**WASILLA PLANNING COMMISSION
RESOLUTION SERIAL NO. 15-01(AM)**

A RESOLUTION OF THE WASILLA PLANNING COMMISSION APPROVING USE PERMIT NUMBER U14-04 TO BUILD A NEW 39,862 SQUARE FOOT IDITAROD ELEMENTARY SCHOOL, LOCATED ON LOT C21, TOWNSHIP 17 NORTH, RANGE 1 WEST, SECTION 3 AND TRACT A, PJC SUBDIVISION.

SHEET NO. C210	IDITAROD ELEMENTARY SCHOOL Kuskooguk Borough School District 1001 N. Fishhook Rd. Wasilla, Alaska
	SITE PLAN

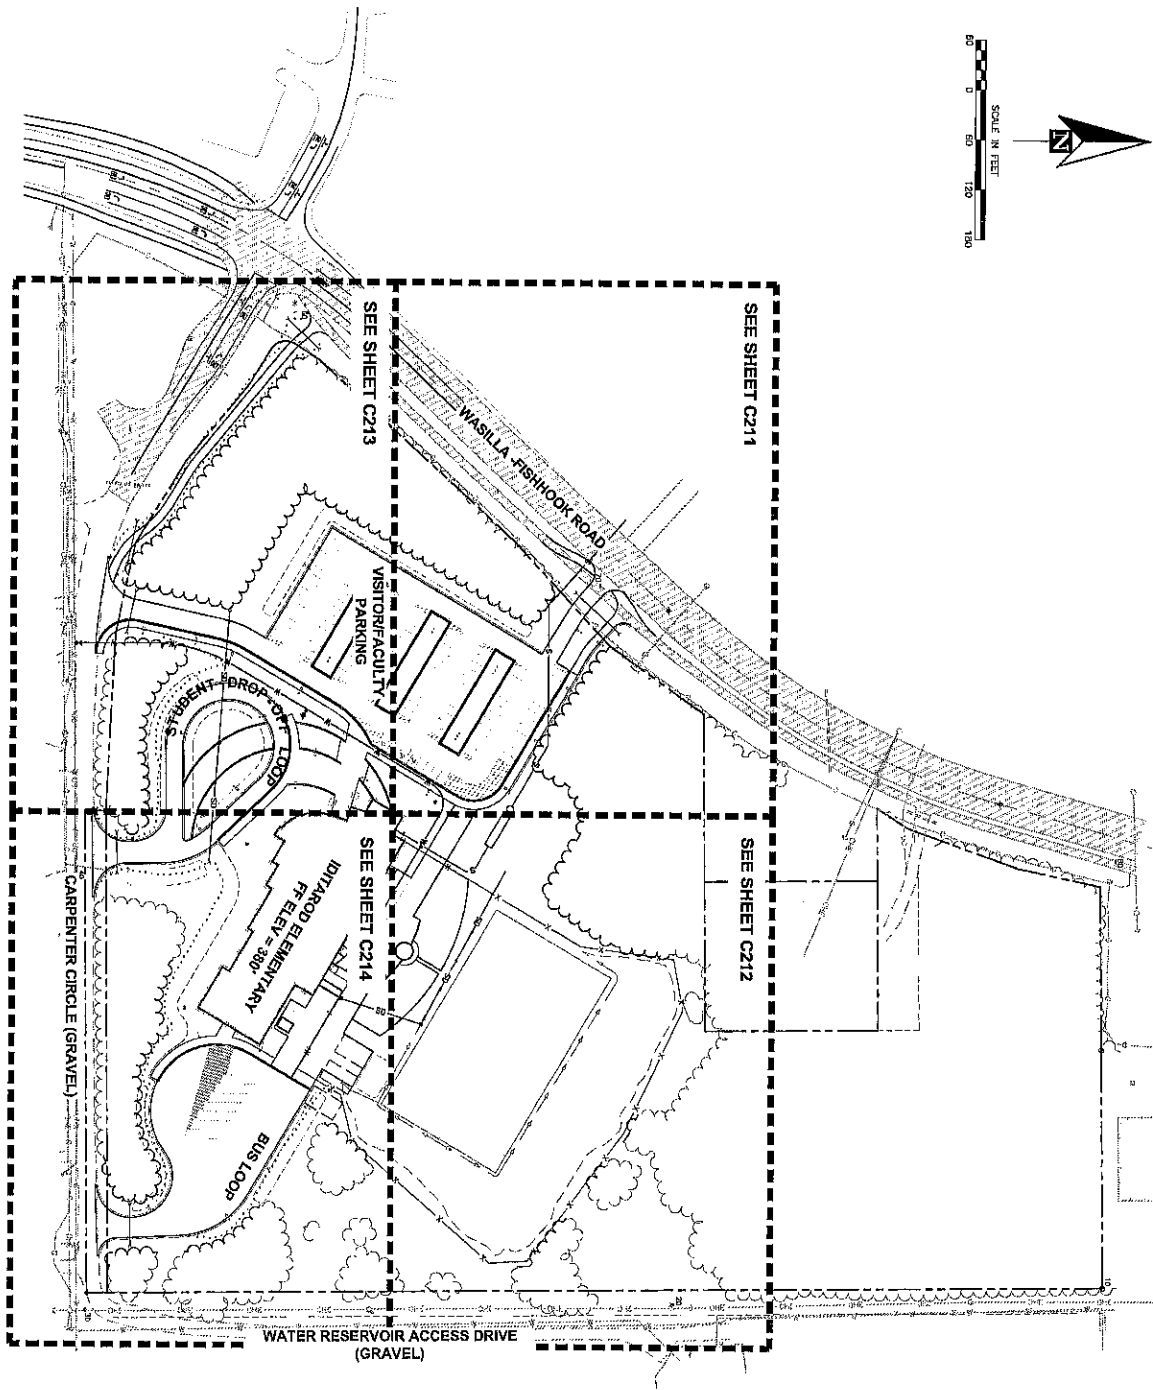
The site plan proposes four access points – three on E. Carpenter Circle and one “exit only” on Wasilla-Fishhook Road.

The eastern access will be only for buses accessing the school. Since there will only be 5-7 buses twice a day, this should not negatively impact the nearby residences.

The middle access on E. Carpenter Circle is for the student drop-off/pick-up loop, which will only allow queuing for approximately 16 vehicles (320'± in length for drop off portion of loop). This short queuing length in the loop will cause vehicles to begin queuing in the eastbound lane of E. Carpenter while waiting for the line to move. Approximately 40 cars could queue in the roadway before backing up into Wasilla-Fishhook Road. This queuing on E. Carpenter Lane would block the residents from exiting their homes in their vehicles during peak traffic periods. With the current loop design, all cars will be required to enter and exit the school via E. Carpenter Circle since there is no connectivity to the exit from the parking lot onto Wasilla-Fishhook Road.

The western access is only intended as access to the parking lot for all teachers and visitors. However, since the drive aisle goes past the school, it may also be used as an “unofficial” drop-off/pick-up queuing area, which will create two access points with significant vehicle traffic during peak school hours.

Finding: The proposed design for the elementary school with separate access points for the drop-off/pick-up loop, the parking lot, and the bus area will significantly increase the traffic along E. Carpenter Circle. It may also create a danger to pedestrians since there are no sidewalks on E. Carpenter Circle.

However, the proposed vehicular circulation and access points onto E. Carpenter Circle will negatively impact the circulation of vehicles, pedestrian, and bicycles along E. Carpenter Circle. If the new elementary school is limited to two access points onto E. Carpenter Circle, this will minimize the impacts to safety and circulation.

Finding: The proposed design for the elementary school with three access points onto E. Carpenter Circle will result in significantly different peak use characteristics than the surrounding uses or area, which is currently developed with nine single-family homes.

1. Only two access points may be constructed onto E. Carpenter Circle – one for the bus only area and one combined access for the drop-off/pick-up and parking area. Any additional driveways must utilize Wasilla-Fishhook Road. An updated site plan showing the revised driveway locations must be submitted to the Planning Department and Public Works Department for review and approval prior to beginning construction on the site.

Staff is recommending that the Planning Commission add two conditions to the use permit approval. The first condition would limit the new elementary school to two access points onto E. Carpenter Circle. The second condition is that the proposed sidewalk be extended to the eastern property line along the north side of E. Carpenter. This sidewalk extension will provide connectivity between the new elementary school and Wasilla High School and it will provide a safe area for the neighbors to walk in the neighborhood and to shopping areas.

Staff is recommending that the Planning Commission add two conditions. The first would be to limit the new elementary school to two access points – one for the bus area and one for the drop-off/pick-up loop and parking areas. This redesign will minimize the number of vehicle trips along E. Carpenter Circle since vehicles would have the choice to exit directly onto Wasilla-Fishhook Road instead of utilizing E. Carpenter Circle as an exit. The second condition would be to require extension of the proposed sidewalk to the eastern property boundary. This would provide a safe walking area for residents in the area and also provide pedestrian connectivity from Wasilla-Fishhook Road to Wasilla High School.

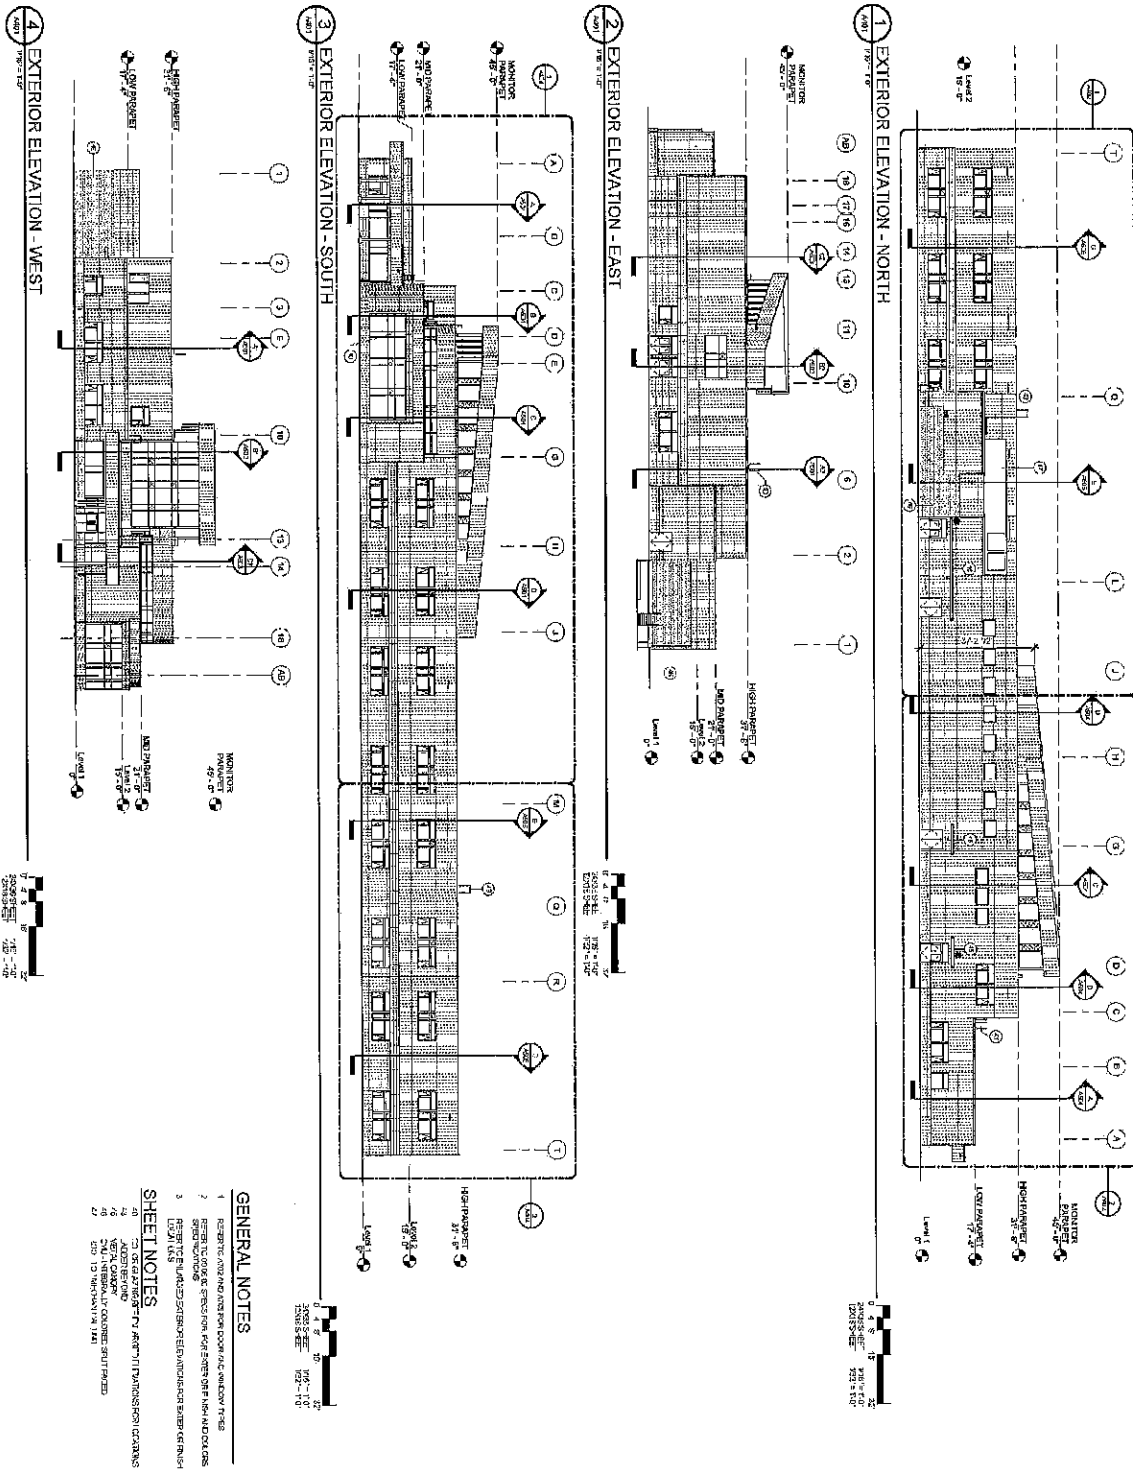
Finding: The attached site plan submitted by the applicant complies with the minimum setbacks requirements of §16.24.010. The proposed building does not comply with the maximum 35' building height. The proposed building contains an architectural roof feature that allows light into the main area of the school. However, the applicant has submitted a variance application seeking a 10' variance to allow construction of this feature.
